**From:** Jared Romero, P.E., CFM, Development Review Engineer  
AMAFCA

**RE:** **AMAFCA COMMENTS FOR**  
**Pino Arroyo at the Foothills – LOMR dated 6/7/2023**

## AMAFCA Comments for Juan Tabo Hills Estates - LOMR

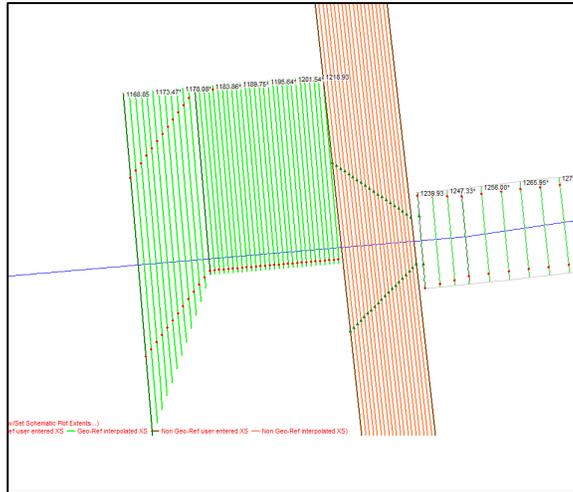
- There are cross sections that are not drawn perpendicular to flow and are likely to inaccurately represent the flow area of the channelization.
- There is an error indicating that “21 of the 431 XS’s are not Geo-Referenced. This error should be addressed.
- There is some error with how the cross sections are offset from the flowline in the model. This may not affect the calculations however it may raise questions from FEMA and should be fixed.

- How were the ineffective flow areas determined for the Channel downstream of the single CBC? They should be set to an elevation at least as high as the retaining walls on the downstream side of the CBC.

### As-Built Plans

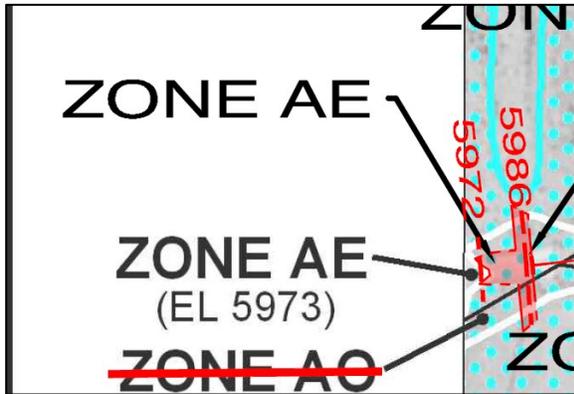
- There are several elevations in the HEC-RAS model that do not match the ground elevations in the as-built plans that need to be revised:
  - a. Channel connection to existing concrete rundown into Pino Dam: As-Built = 5977.82', Model = 5977.60'
  - b. Downstream headwall of CBC: As-builts = 5978.62', Model = 5978.60'
  - c. Grade Break in downstream CBC: As-builts = 5985.08', Model = 5985.00'
